Professional Snagging Inspection Report

Post-completion inspection

Inspection date: 18 July 2026

LOCATION	RECOMMENDED TRADE	RISK CATEGORY
Bedroom 3	Decorator	Finish / workmanship

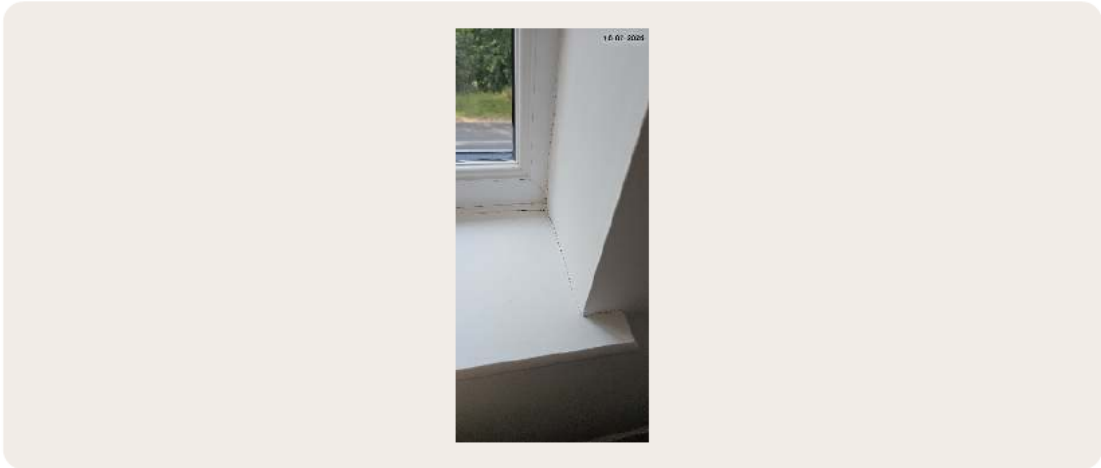
OBSERVATION
A visible shrinkage gap has opened around the bedroom 3 window junction at recorded location 1 of 2.

RECOMMENDED ACTION
Prepare the affected junction, remove loose caulk, apply suitable decorator's caulk, smooth it neatly and redecorate to match the surrounding finish.

LOCATION	RECOMMENDED TRADE	RISK CATEGORY
Bedroom 3	Decorator	Finish / workmanship

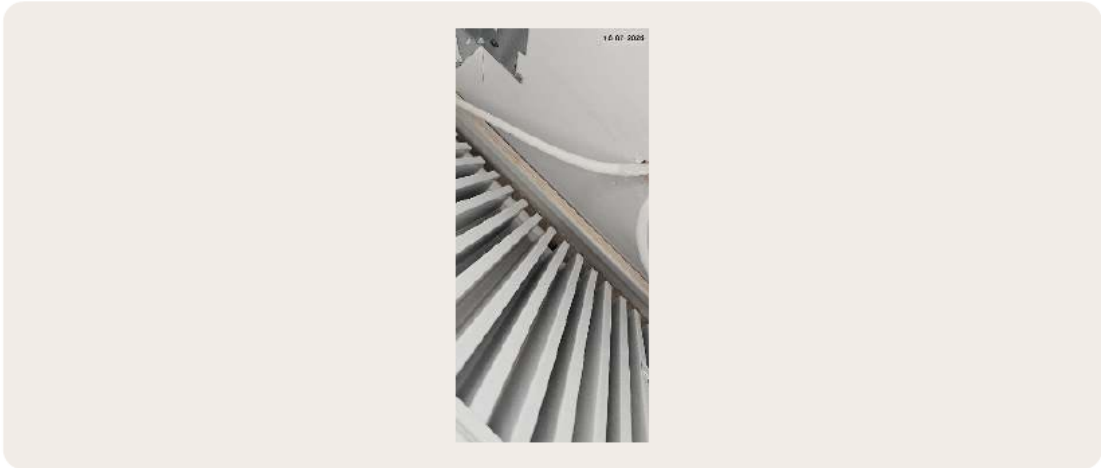
OBSERVATION
The skirting board has not been decorated.

LOCATION	RECOMMENDED TRADE	RISK CATEGORY
Bedroom 3	Window fitter	Finish / operation

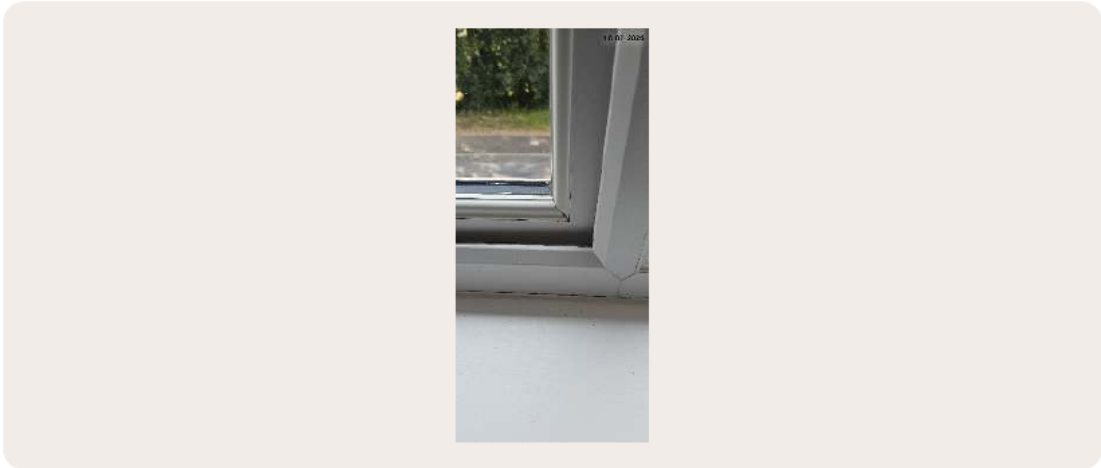
OBSERVATION
The window catches on the receiver and requires adjustment.

RECOMMENDED ACTION
The window fitter should adjust, repair or replace the affected item and confirm correct operation, alignment and weather sealing in accordance with the manufacturer instructions.

LOCATION	RECOMMENDED TRADE	RISK CATEGORY
Bedroom 2	Decorator	Finish / workmanship

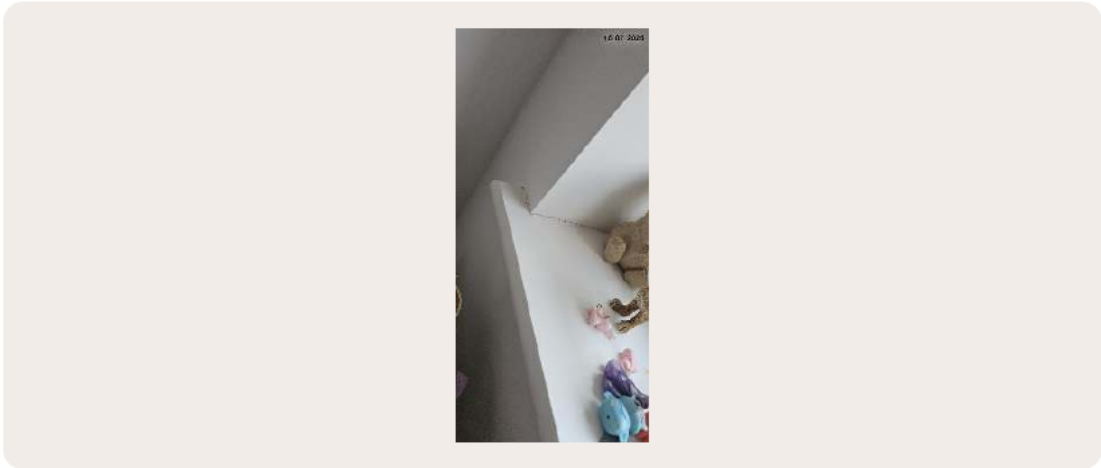
OBSERVATION
A visible shrinkage gap has opened around the bedroom 2 window junction at recorded location 3 of 3.

RECOMMENDED ACTION
Prepare the affected junction, remove loose caulk, apply suitable decorator's caulk, smooth it neatly and redecorate to match the surrounding finish.

LOCATION	RECOMMENDED TRADE	RISK CATEGORY
Bedroom 2	Decorator	Finish / workmanship

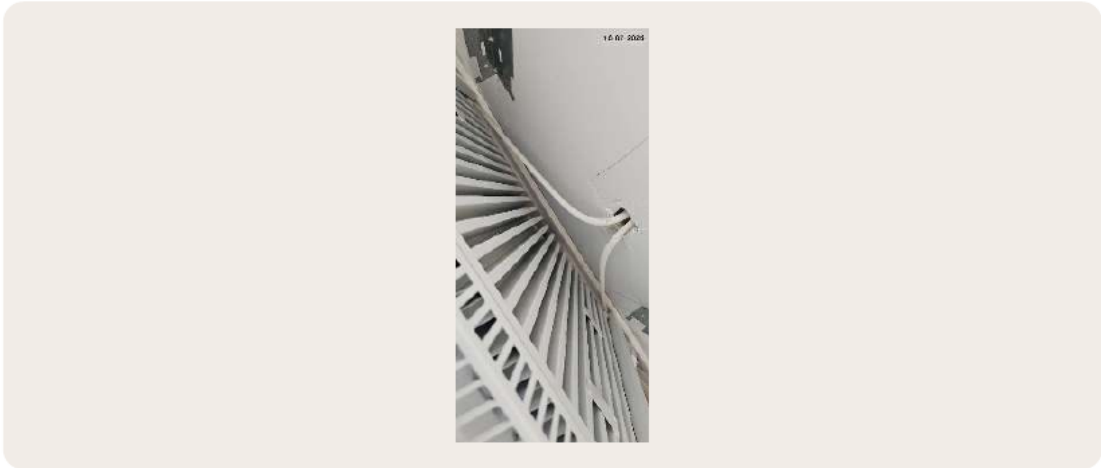
The skirting board behind the radiator has not been decorated.

LOCATION	RECOMMENDED TRADE	RISK CATEGORY
Bathroom	Decorator	Water tightness / services

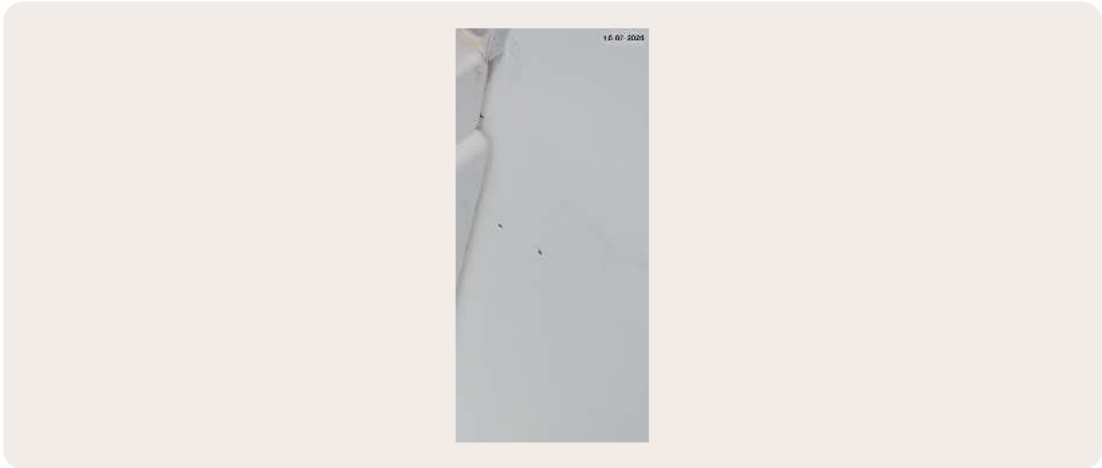
OBSERVATION
Holes remain in the wall beside the bath panel.

LOCATION	RECOMMENDED TRADE	RISK CATEGORY
Bedroom 1	Decorator	Finish / workmanship

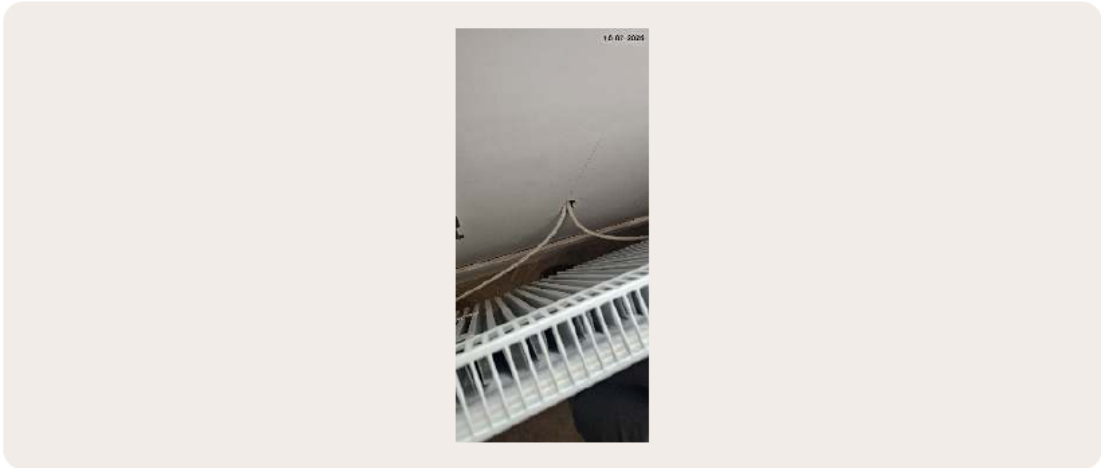
OBSERVATION
The skirting board behind the radiator has not been decorated.

LOCATION	RECOMMENDED TRADE	RISK CATEGORY
Bedroom 1	Decorator	Finish / workmanship

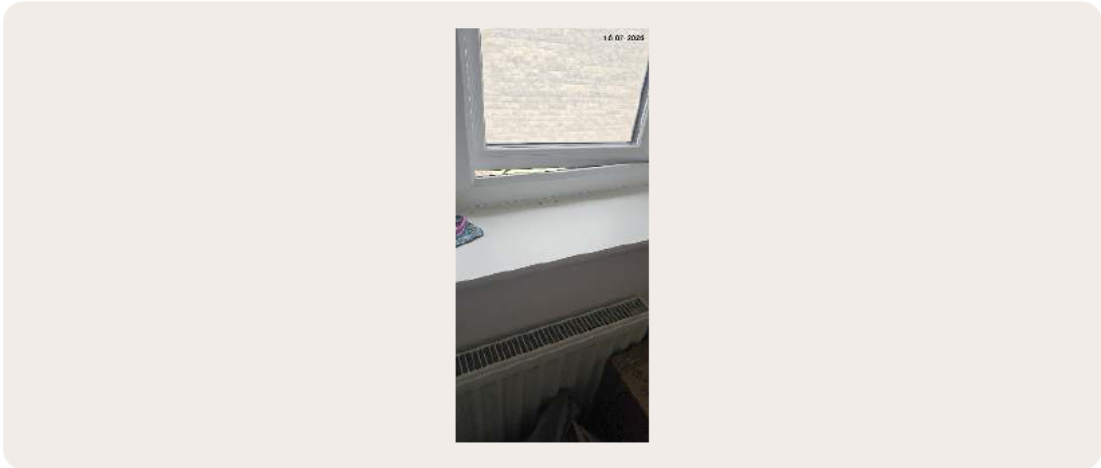
OBSERVATION
A visible shrinkage gap has opened around the bedroom 1 window junction at recorded location 2 of 3.

RECOMMENDED ACTION
Prepare the affected junction, remove loose caulk, apply suitable decorator's caulk, smooth it neatly and redecorate to match the surrounding finish.

LOCATION	RECOMMENDED TRADE	RISK CATEGORY
Bedroom 1	Decorator	Finish / workmanship

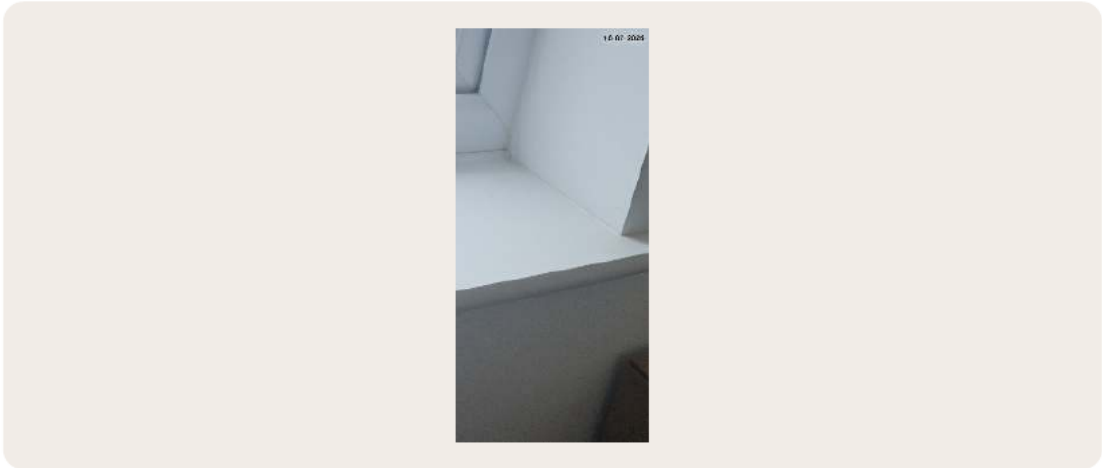
OBSERVATION
A visible shrinkage gap has opened around the bedroom 1 window junction at recorded location 3 of 3.

RECOMMENDED ACTION
Prepare the affected junction, remove loose caulk, apply suitable decorator's caulk, smooth it neatly and redecorate to match the surrounding finish.

LOCATION	RECOMMENDED TRADE	RISK CATEGORY
Bedroom 1	Carpenter	Finish / operation

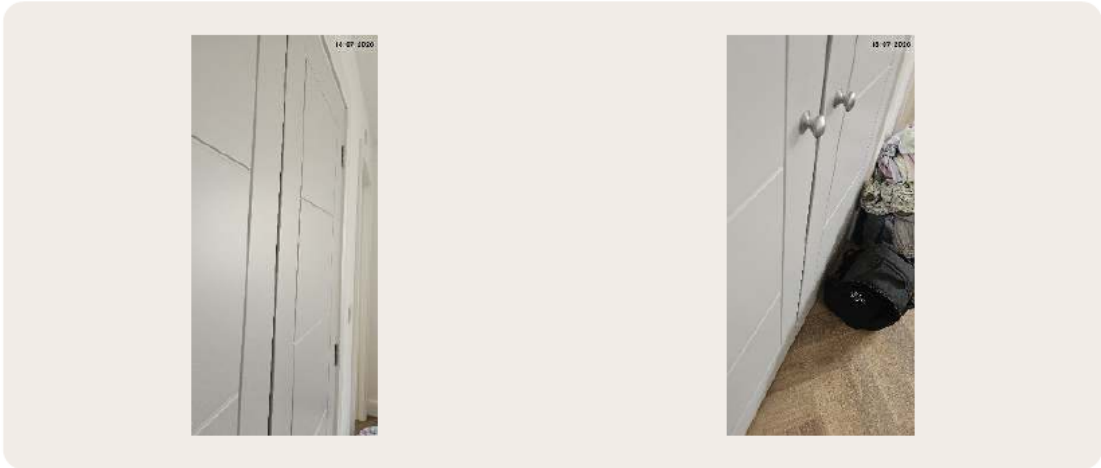
OBSERVATION
The wardrobe doors are warped.

RECOMMENDED ACTION
Adjust, secure, ease, repair or replace the affected item as required, then make good disturbed finishes and confirm correct operation.

LOCATION	RECOMMENDED TRADE	RISK CATEGORY
Bathroom	Decorator	Finish / workmanship

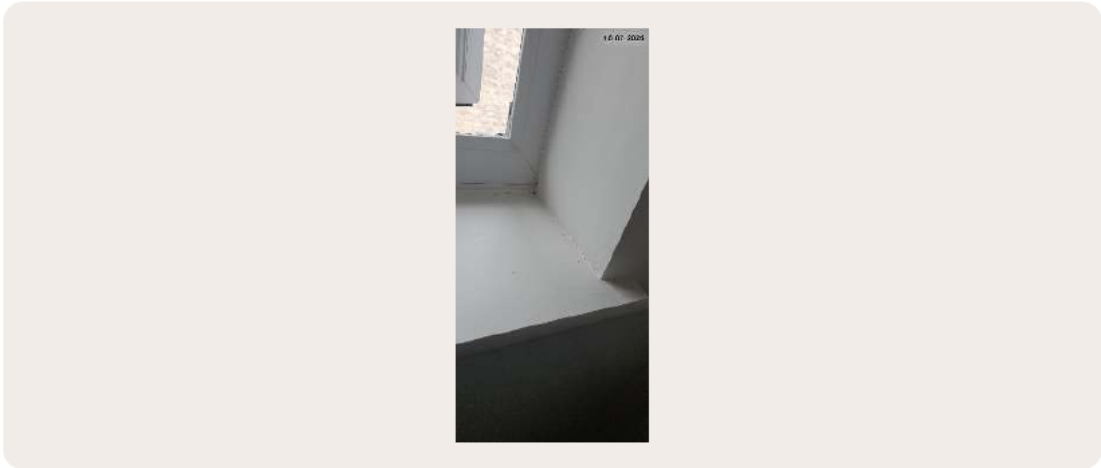
OBSERVATION
A visible shrinkage gap has opened around the en suite window junction at recorded location 1 of 2.

RECOMMENDED ACTION
Prepare the affected junction, remove loose caulk, apply suitable decorator's caulk, smooth it neatly and redecorate to match the surrounding finish.

LOCATION	RECOMMENDED TRADE	RISK CATEGORY
Bathroom	Decorator	Finish / workmanship

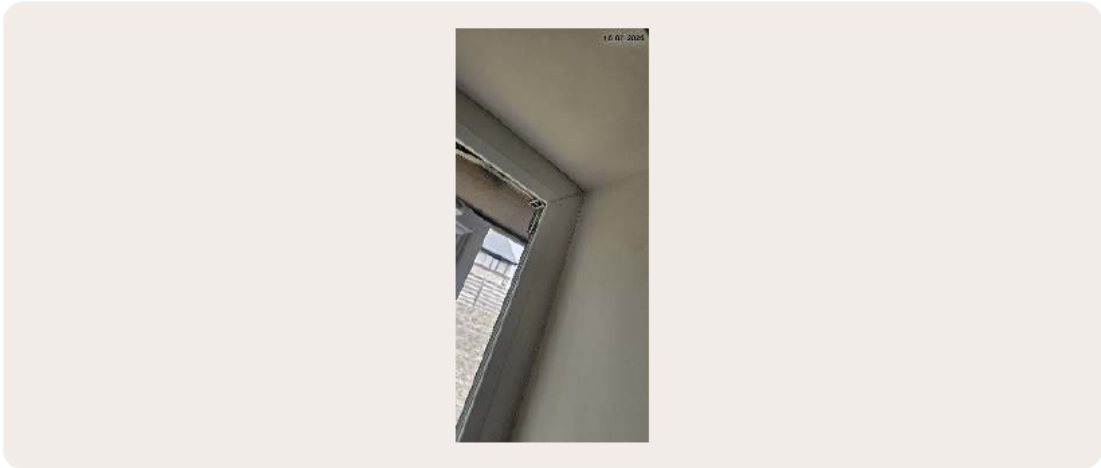
OBSERVATION
A visible shrinkage gap has opened around the en suite window junction at recorded location 2 of 2.

RECOMMENDED ACTION
Prepare the affected junction, remove loose caulk, apply suitable decorator's caulk, smooth it neatly and redecorate to match the surrounding finish.

LOCATION	RECOMMENDED TRADE	RISK CATEGORY
En suite	Plasterer / dryliner	Finish / workmanship

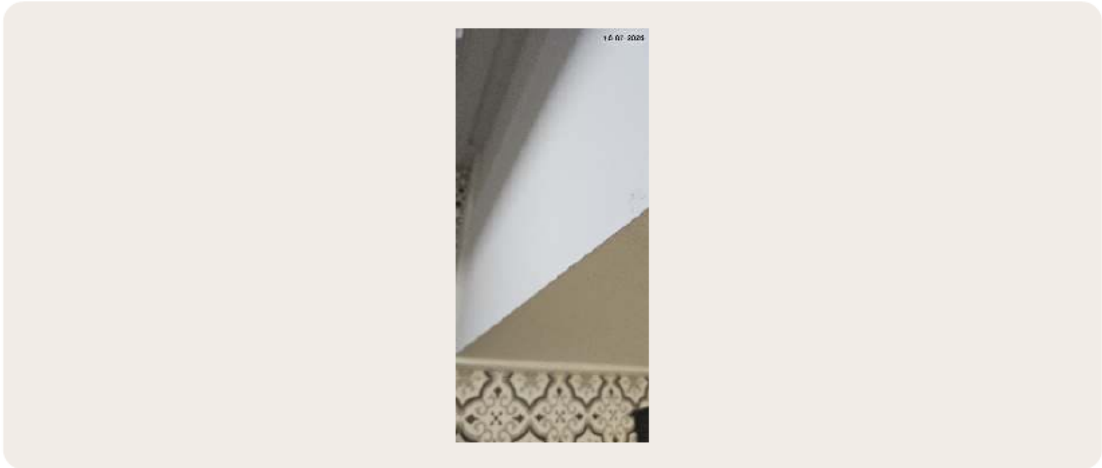
OBSERVATION
The external corner bead is corroding and staining the surrounding finish.

RECOMMENDED ACTION
The plasterer / dryliner should remove the rusted corner bead, install a suitable corrosion-resistant replacement, make good the surrounding plaster finish and arrange redecoration after the repair has dried.

LOCATION	RECOMMENDED TRADE	RISK CATEGORY
External	Carpenter	Finish / operation

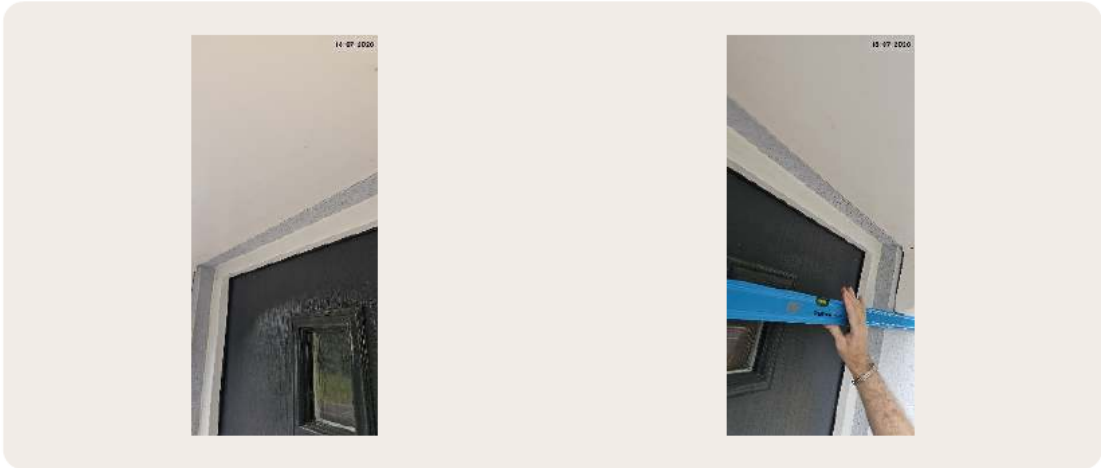
OBSERVATION
The entrance canopy is misaligned with the adjoining render bead, resulting in an uneven and poorly coordinated junction.

WHY THIS MATTERS
The canopy and adjoining render detail should be aligned, securely fixed and coordinated to provide a neat, durable and weather-resistant junction.

Principal access - residential dwelling

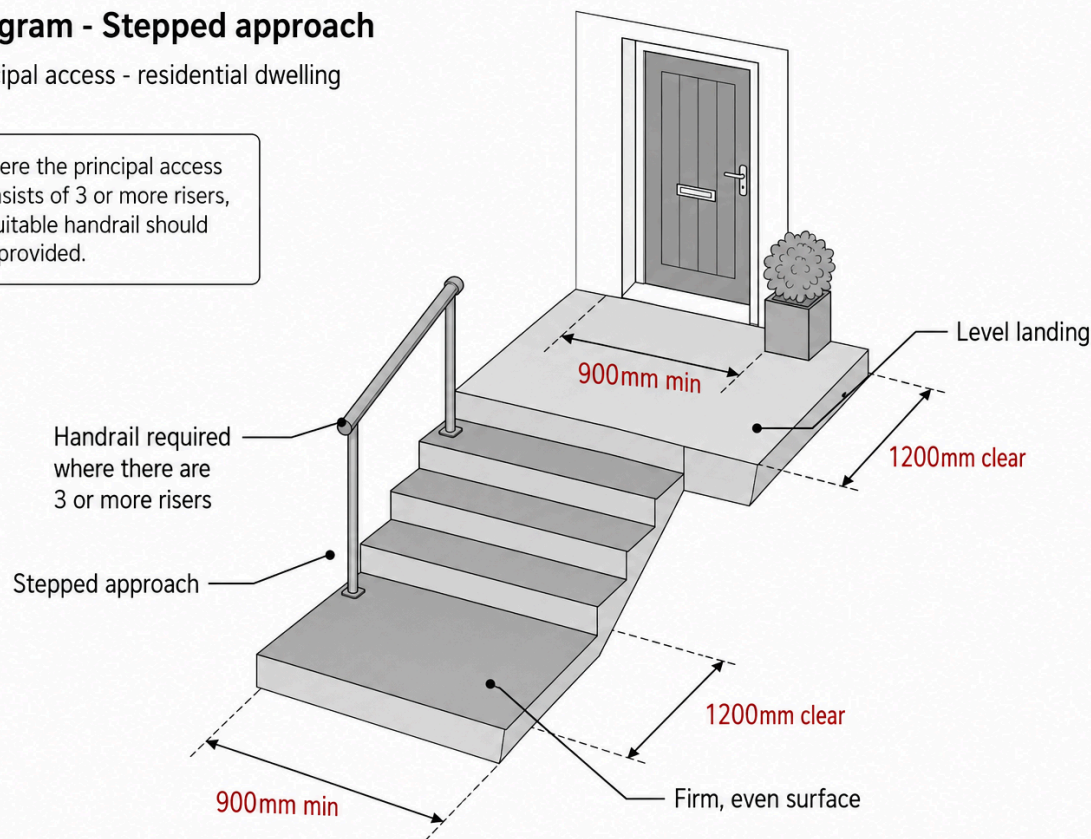
OBSERVATION
The approach to the principal entrance does not provide a suitable level, ramped or compliant stepped access arrangement.

WHY THIS MATTERS
The principal approach should provide reasonable access for occupants and visitors, including people with restricted mobility. Unsuitable gradients, cross-falls, abrupt level changes or deficient landings may prevent safe and convenient access.

Where the principal access consists of 3 or more risers, a suitable handrail should be provided.

LOCATION	RECOMMENDED TRADE	RISK CATEGORY
External envelope	Plastic surgeon	Finish / operation

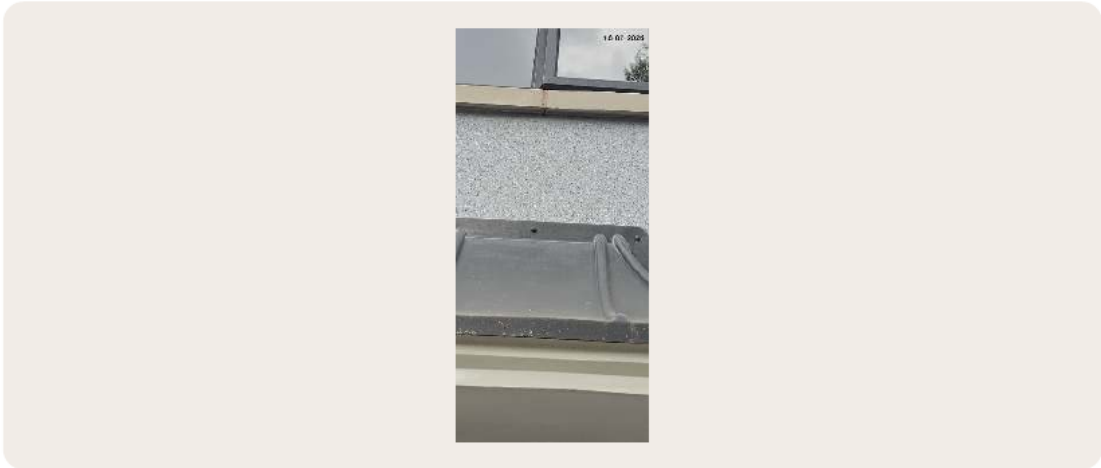
OBSERVATION
The bedroom 3 window sill is locally damaged and requires a specialist colour-matched repair.

LOCATION	RECOMMENDED TRADE	RISK CATEGORY
External envelope	Bricklayer	External envelope / durability

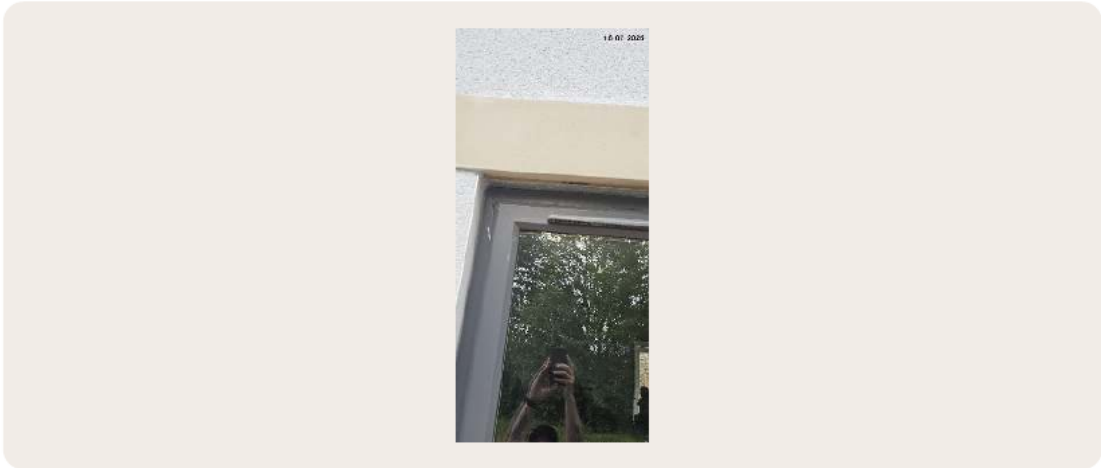
OBSERVATION
The lintel is not fully bedded.

LOCATION	RECOMMENDED TRADE	RISK CATEGORY
External	Bricklayer	External envelope / durability

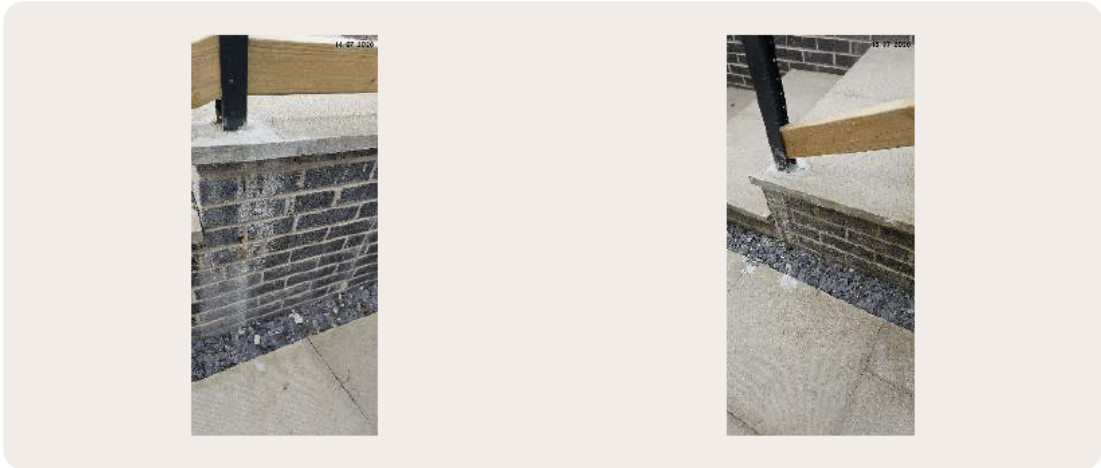
OBSERVATION
Concrete staining is visible across the brickwork adjacent to the external wall and retaining features.
